UNITED STATES PATENT AND TRADEMARK OFFICE

APPLICATION NO.	FILING DATE	FIRST NAMED INVENTOR	ATTORNEY DOCKET NO.	CONFIRMATION NO.
10/588,927	08/03/2007	Irwin Aberin	1431.168.101/FIN 581 PCT/	9898
25281 7590 07/28/2010 DICKE, BILLIG & CZAJA FIFTH STREET TOWERS 100 SOUTH FIFTH STREET, SUITE 2250 MINNEAPOLIS, MN 55402			EXAMINER JUNG, MICHAEL	
			ART UNIT 2895	PAPER NUMBER
			MAIL DATE 07/28/2010	DELIVERY MODE PAPER

Office Action Summary	Application No. 10/588,927	Applicant(s) ABERIN ET AL.	
	Examiner MICHAEL JUNG	Art Unit 2895

DETAILED ACTION

Annotated Fig. 11 of Takeda

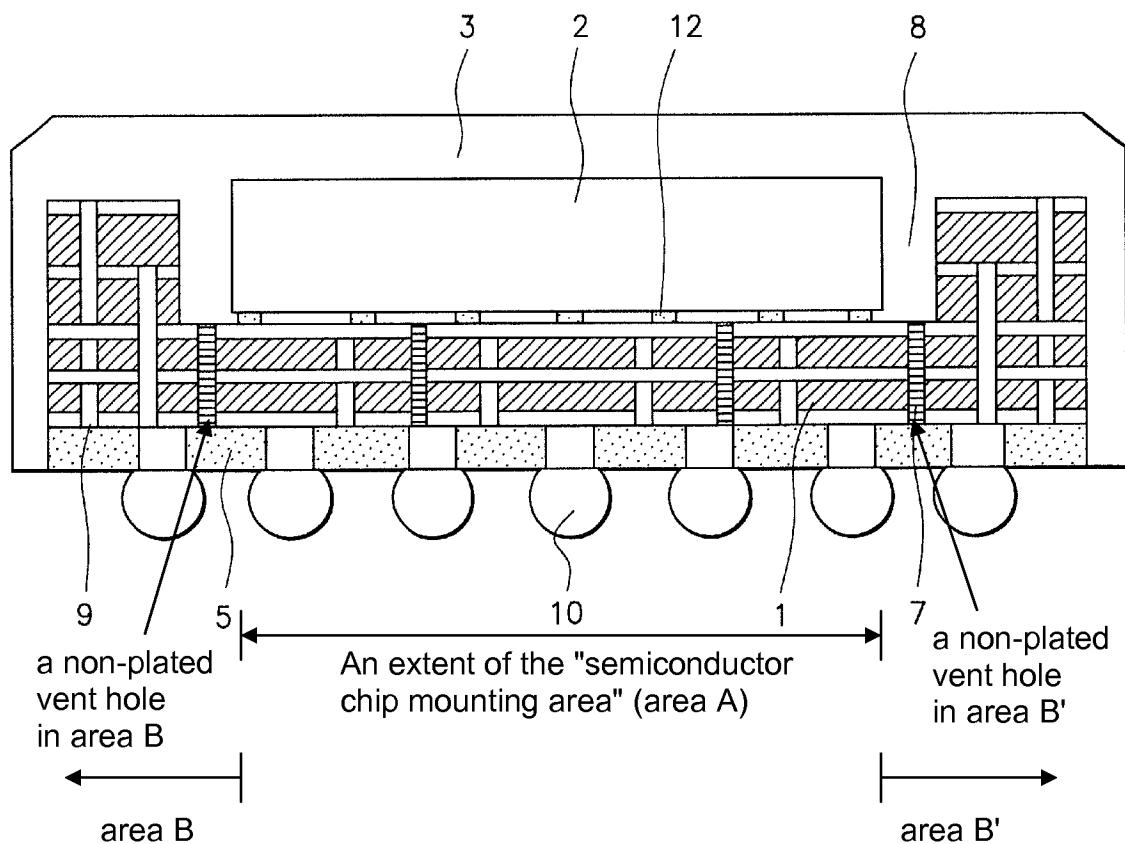
The Annotated Fig. 11 of Takeda (p. 6 of this Office action) shows the non-plated vent holes 7 that are formed in areas B, B' outside of the semiconductor chip mounting area A and within the semiconductor chip mounting area A (see also rejection of claim

17 below.). The Annotated Fig. 11 of Takeda also shows the non-plated vent holes 7 that are disposed in both an area A of the substrate 1 directly underneath the semiconductor chip 2 and in areas B, B' adjacent but not directly underneath the semiconductor chip 2 (see also rejection of claim 22 below).

forming a plurality of non-plated vent holes through the substrate 1 within a semiconductor chip mounting area A (see Annotated Fig. 11 of Takeda) defined on the upper surface and in areas B, B' (see Annotated Fig. 11 of Takeda) of the substrate 1 adjacent to but outside of the semiconductor chip mounting area A (Annotated Fig. 11 of

Takeda shows two non-plated vent holes 7, 7 within the area A and two non-plated vent holes 7, 7 in the areas B, B'.);

a plurality of non-plated vent holes 7 (col. 6, ln 4-7 - "vapor holes 7") through the sheet within the semiconductor chip mounting area A (Annotated Fig. 11 of Takeda shows two vapor holes 7, 7 situated directly underneath the chip 2.) and in the areas B, B' of the substrate 1 adjacent to the semiconductor chip mounting area A (Annotated Fig. 11 shows a vapor hole 7 formed in an area B to the left of the mounting area and another vapor hole 7 formed in an area B' to the right of the mounting area.); and

Regarding claim 28, the modified substrate as taught by the combination of Takeda and Takamichi teaches the plurality of vent holes that are laterally located towards the center and towards the outer edges of the substrate (Fig. 11 of Takeda has been modified such that the outer vent holes 7, 7 are omitted in light of Takamichi's teaching).

a plurality of non-plated vent holes 7 (col. 6, ln 4-7 - "vapor holes 7") through the sheet within a chip mounting area A defined on the upper surface (Annotated Fig. 11 of Takeda shows two vapor holes situated directly underneath the chip 2.) and in areas B, B' adjacent to but outside of the chip mounting area A (Annotated Fig. 11 of Takeda shows a vapor hole formed in an area to the left of the mounting area and another vapor hole formed in an area to the right of the mounting area.); and
